Company	Trenz Electronic GmbH
PCN Number	PCN-20251105
Title	TE0817 Gap Filler Upgrade
Subject	BOM Change
Issue Date	2025-11-11

This change affects all TE0817-02 variants with pre-assembled heat spreader: TE0817-02-xxxxxxxK.

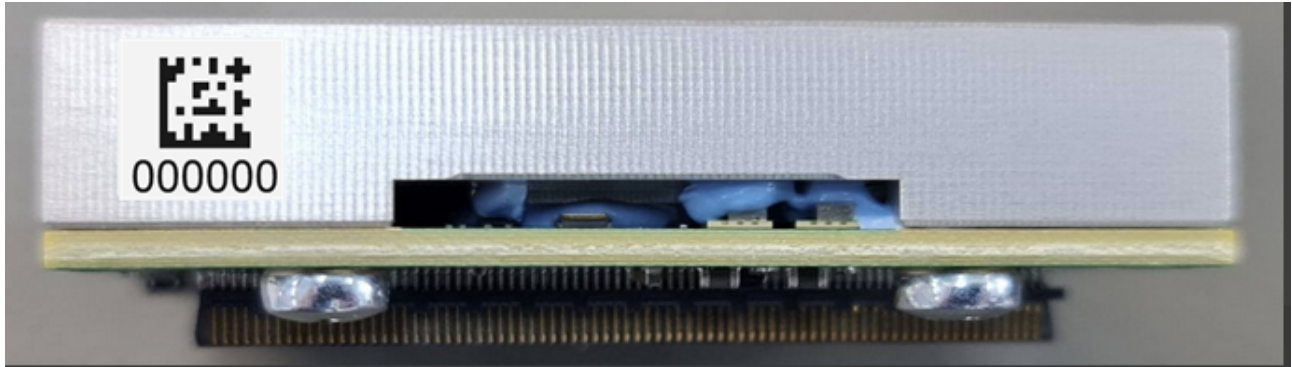
#1 Changed gap filler from GF3500S35-00-60-50CC to GF4500CVO-00-240-50CC.

Reason: Improve thermal conductivity.

Impact: Improved thermal conductivity. Changed colour from blue to pink. For more detailed changes consult gap filler datasheets.
